**SUNDRY NOTICES AND REPORTS ON WELLS**  
*Do not use this form for proposals to drill or to re-enter an abandoned well. Use form 3160-3 (APD) for such proposals.*

8. Well Name and No.  
SAN JUAN 32-7 UNIT 69

Hilcorp Energy Company requests permission to recompletable the subject well in the Mesaverde and downhole commingle with the existing Dakota. Please see the attached procedure, wellbore diagram, plat and gas capture plan. A closed loop system will be used. Interim reclamation will be performed after surface disturbing activities.

Attachment to notice of Intent to Recomplete & Commingle

SAN JUAN 32-7 UNIT 69 - CURRENT WELLBORE SCHEMATIC

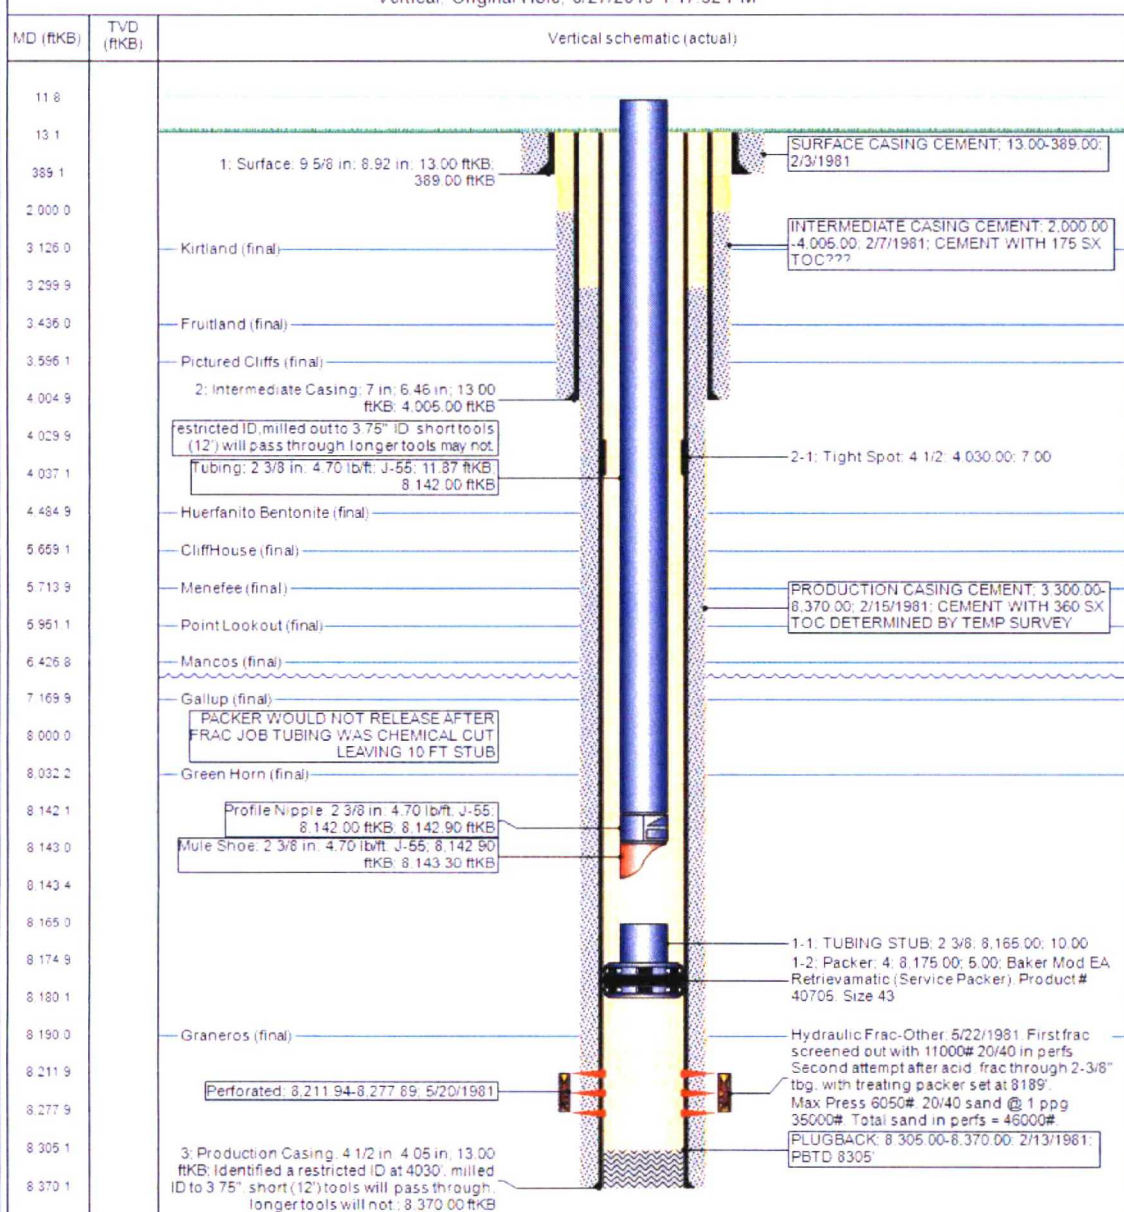
- a) Upon rigging up, record Bradenhead pressure and monitor same during recompletion operations. Notify BLM and NMOCD if anomalous pressure changes occur. Provide monitoring results in the subsequent Report of Operations.
- b) Casing pressure test for fracture stimulation operations cannot exceed the internal yield strength of the casing including a 20% safety factor unless a waiver is granted. Stimulation operations cannot exceed this test pressure.
- c) CIBP for the base of fracture stimulation is to be no more than 50' above the top of tubing stub at 8165' MD.
